AGENDA

The Columbia Architectural Design Review Team will meet on Tuesday, June 7th, 2022 at 8:00 a.m. in Conference Room A on the basement level of City Hall, 700 N. Garden Street to consider the following:

CITY OF COLUMBIA TENNESSEE
 ARCHITECTURAL DESIGN REVIEW
 STAFF REPORT

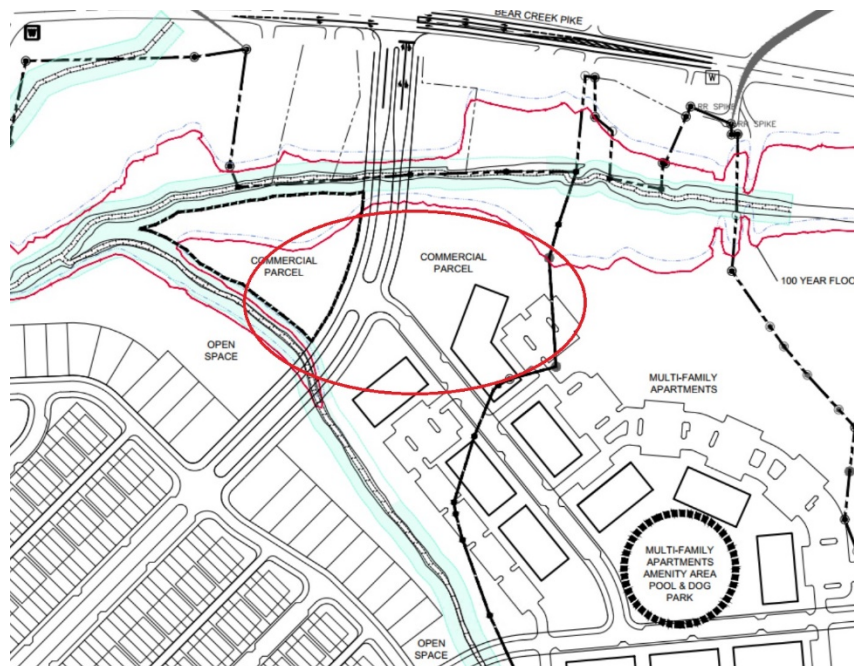
- The front facade (west elevation) consists of a primary material of brick accented by a stone base and fiber cement board clad gables. These materials meet the design standards as referenced with no unbroken façade plane less than 35’.
- The east elevation consists of a primary material of brick accented by a stone base. These materials meet the design standards as referenced with no unbroken façade plane less than 35’
- The south and north elevation consist of a primary façade material of brick accented by a stone base. These materials meet the design standards as referenced with no unbroken façade plane less than 35’. As noted, the mechanical units on the north elevation is proposed to be screened by prefinished metal louvers.

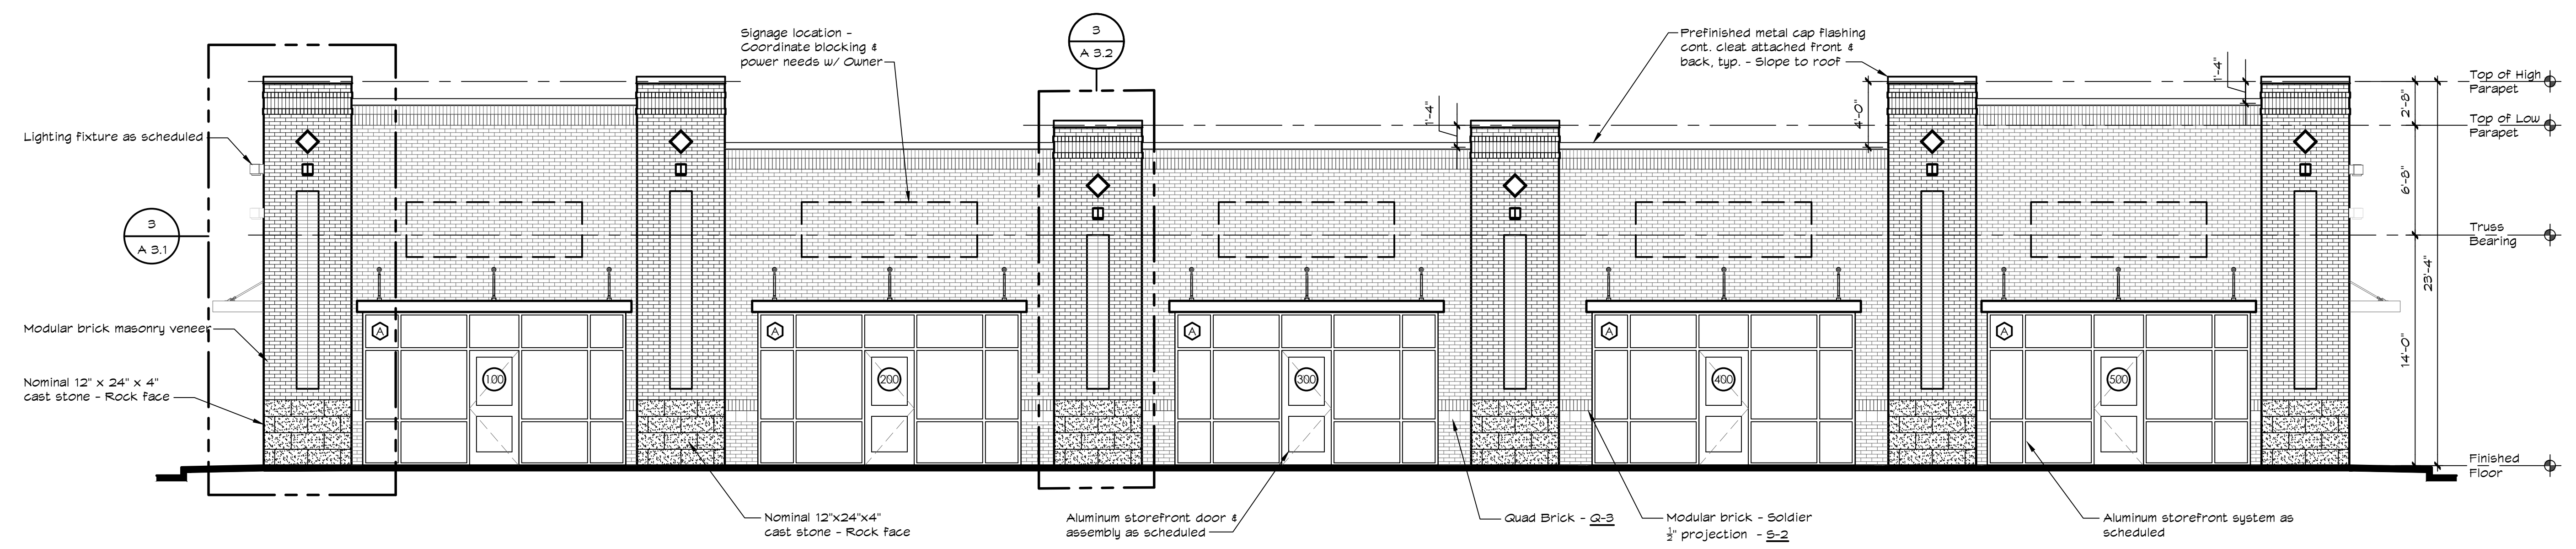
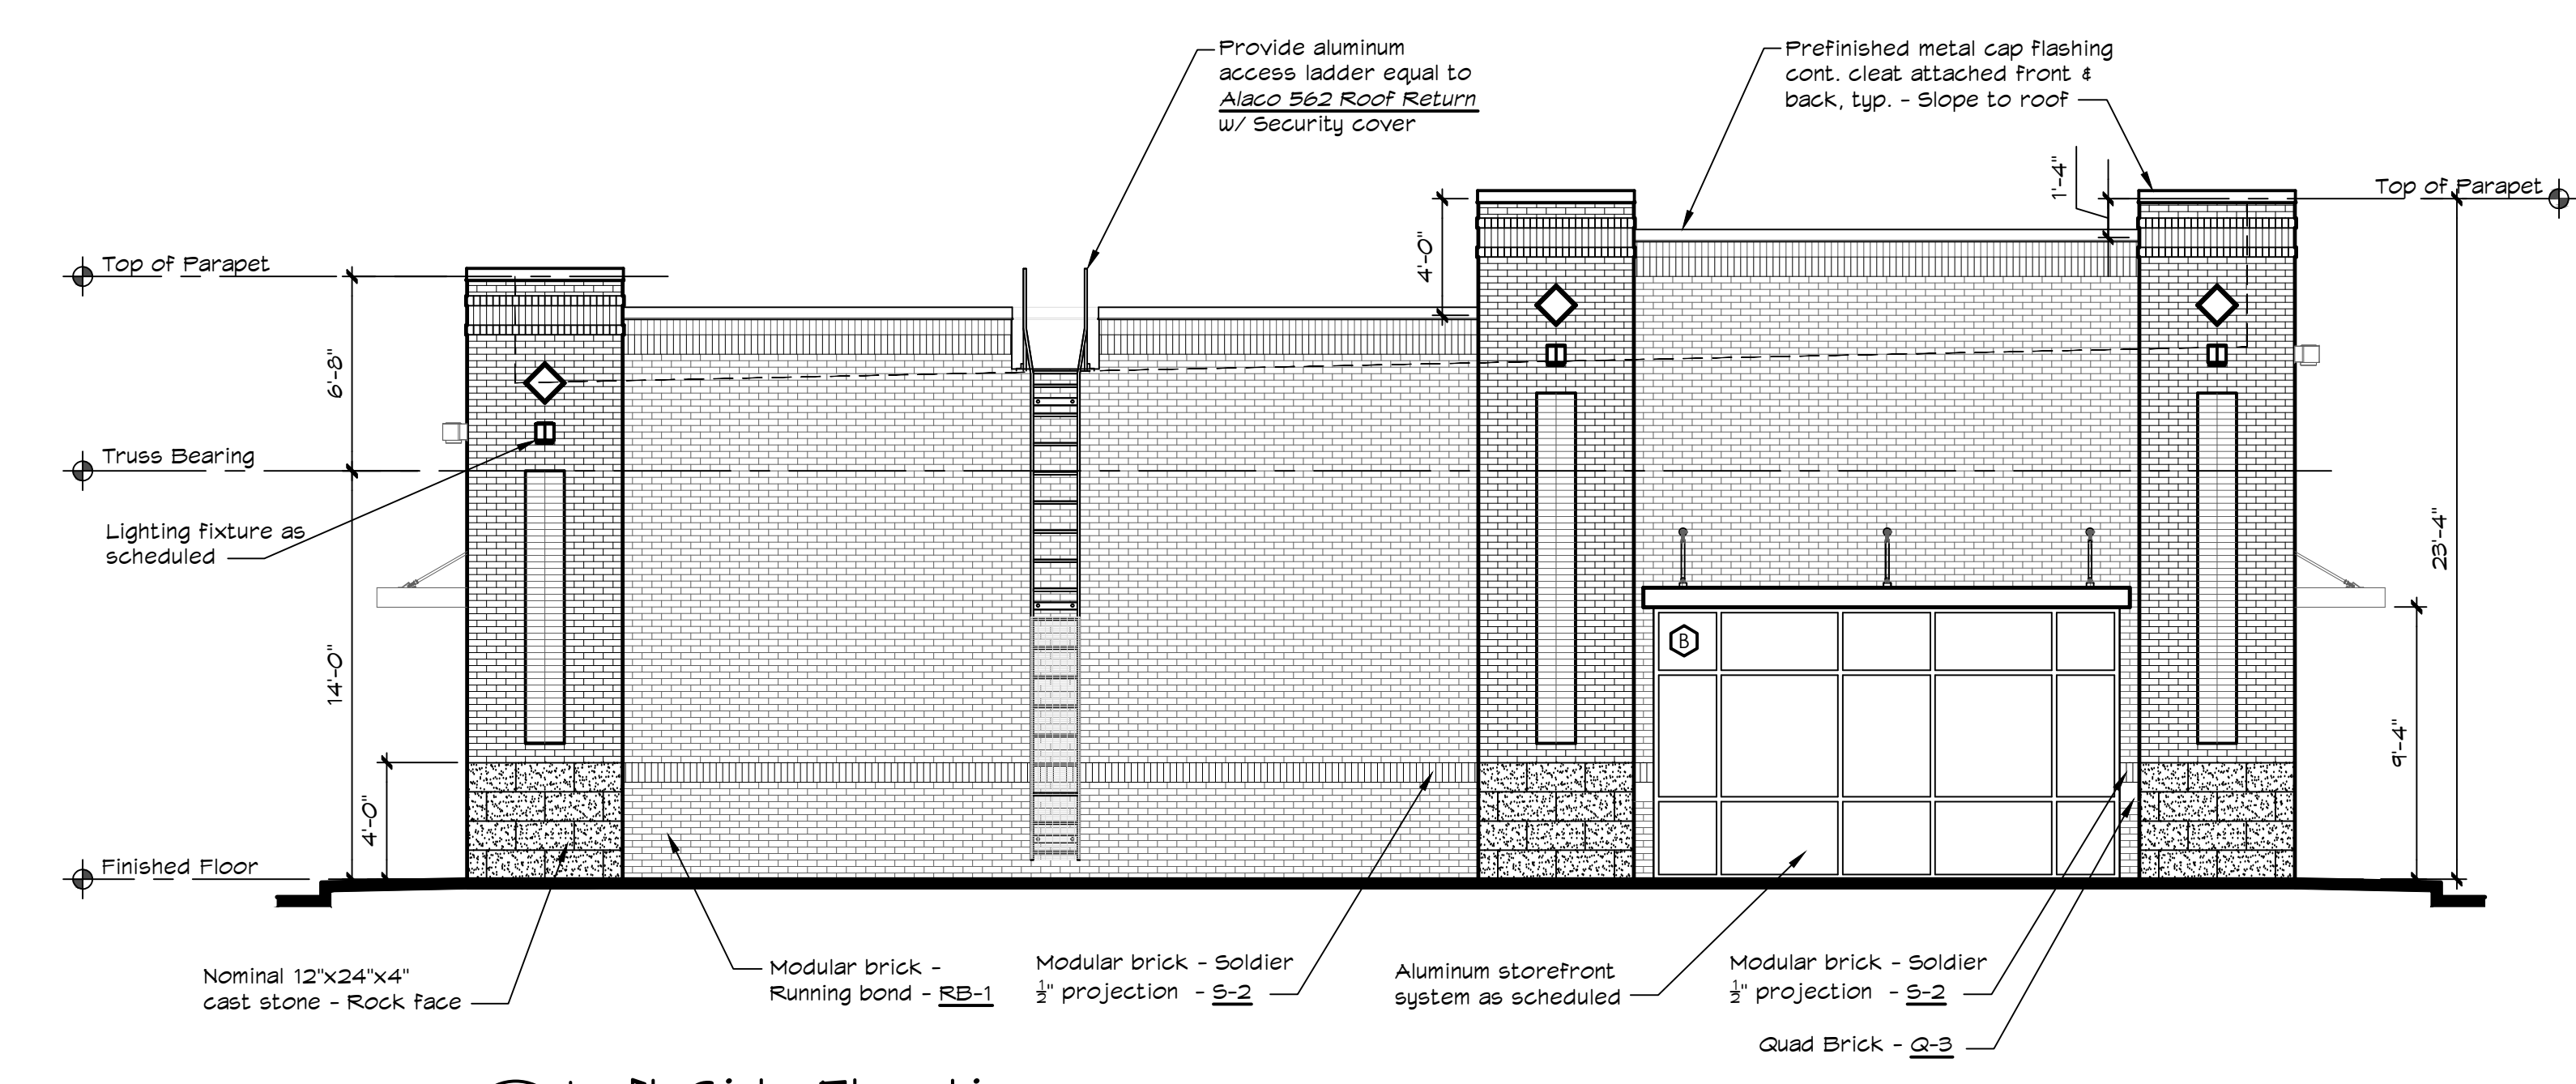
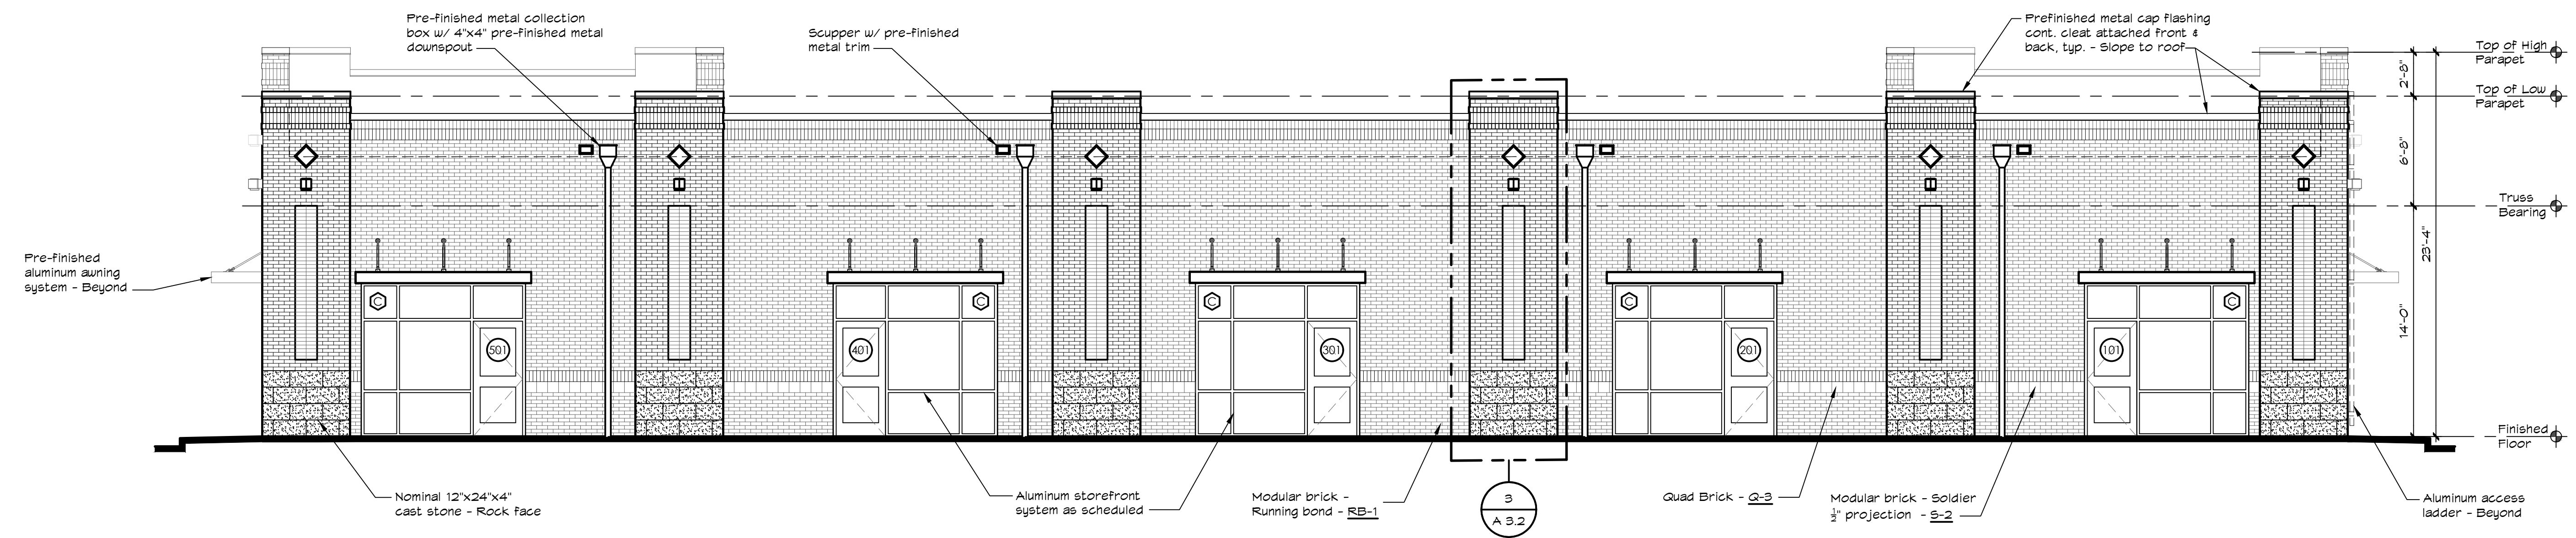
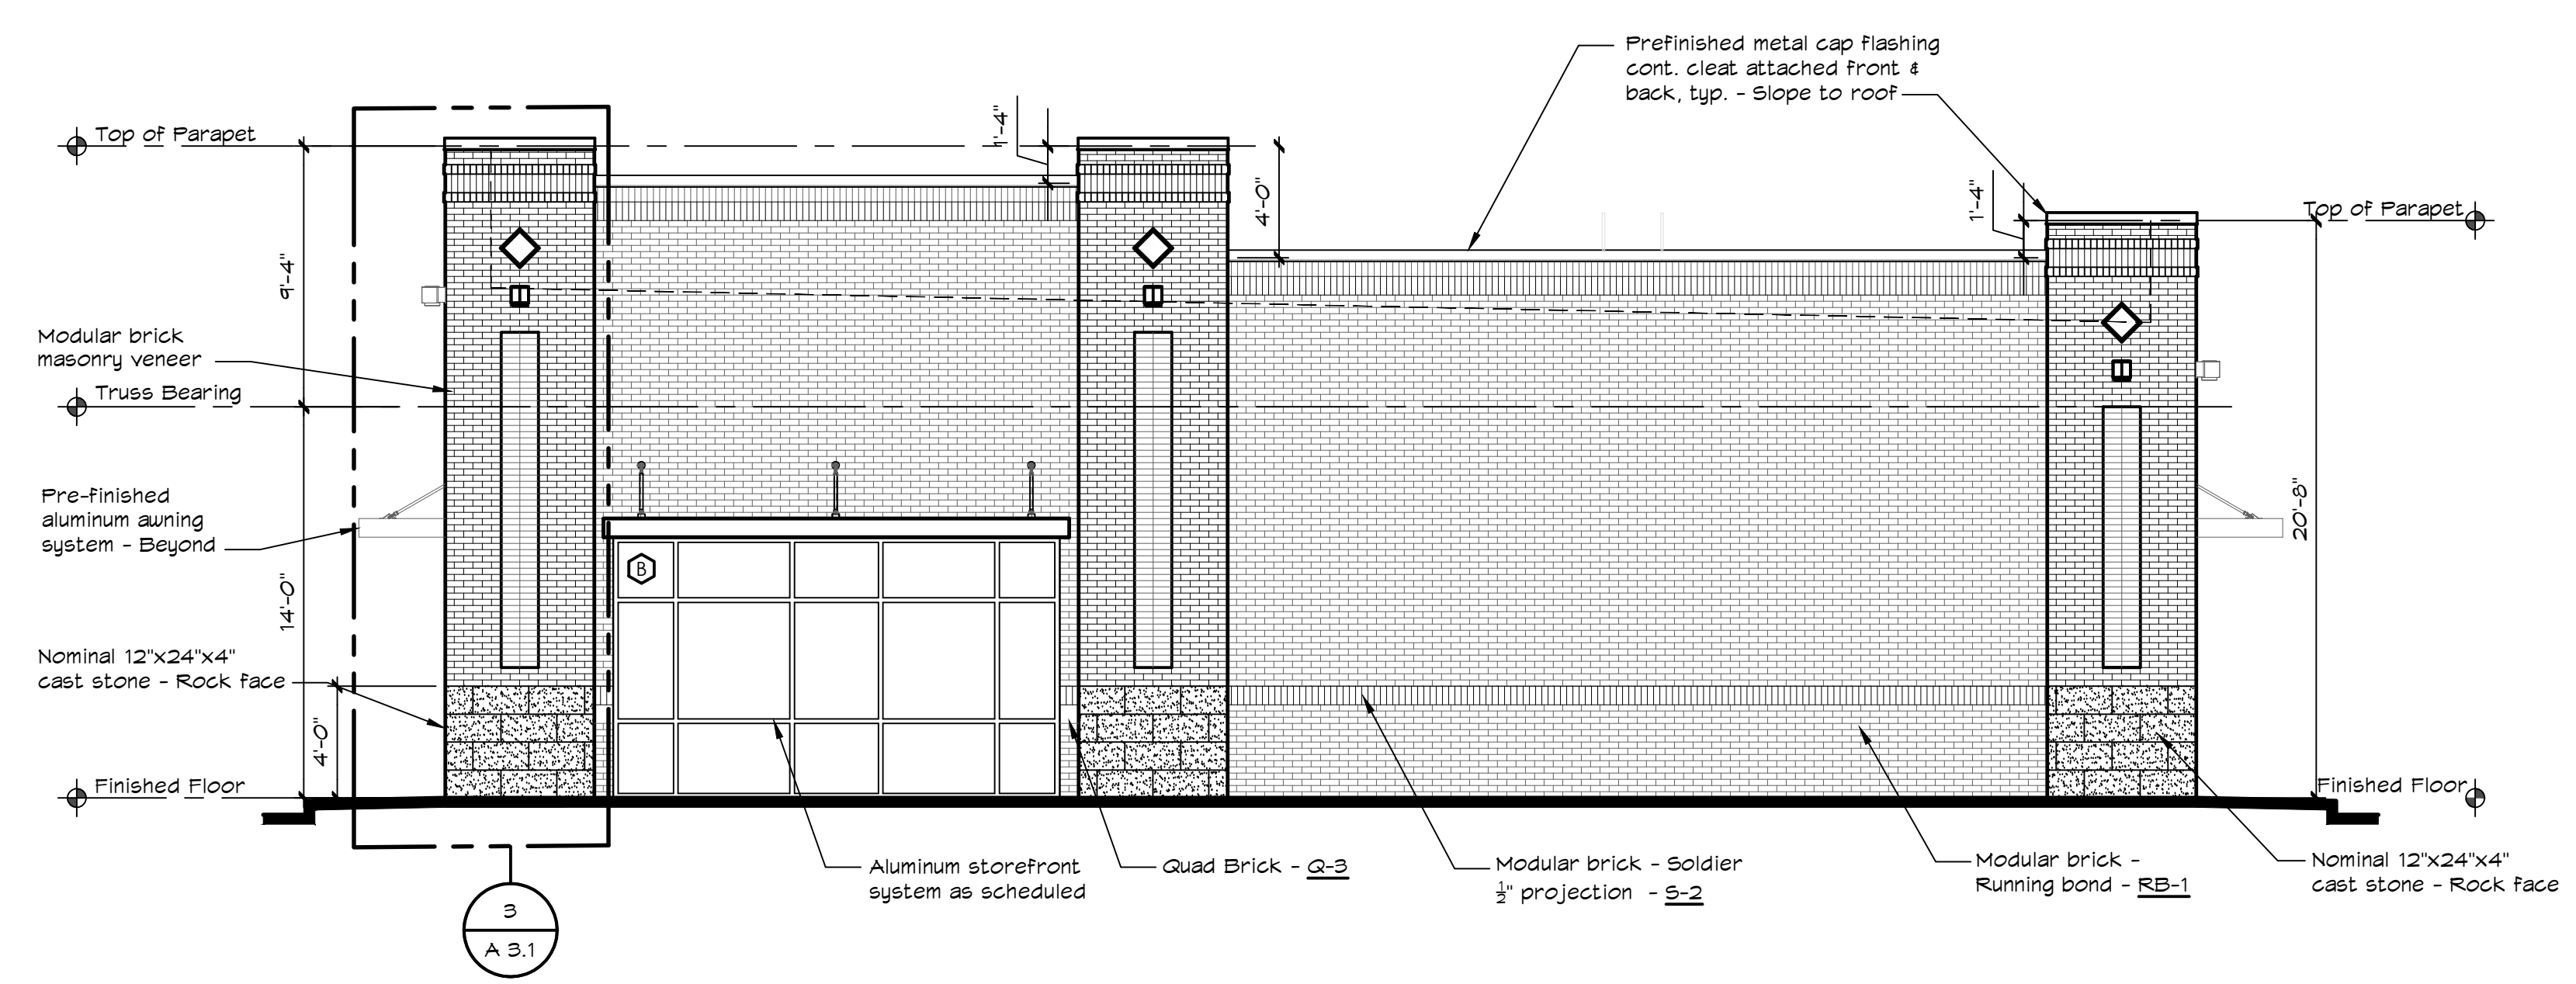
- The proposed west (rear) building elevation will consist of a primary façade material of brick accented by brick soldiering within the base and the columns. Each individual pilaster will be accented by a stone medallion detail. Aluminum storefront windows will be facing the Cayce Lane elevations. The front elevation will consist of the same primary façade materials as the rear elevation with a combination of brick details separated by brick pilasters.
- The right and left (side) elevations will consist of a primary brick material as all other elevations with a 4' recessed parapet.
- It shall be recommended that as a condition of approval that all rooftop HVAC equipment be screened by the raised parapet with no exterior visibility.
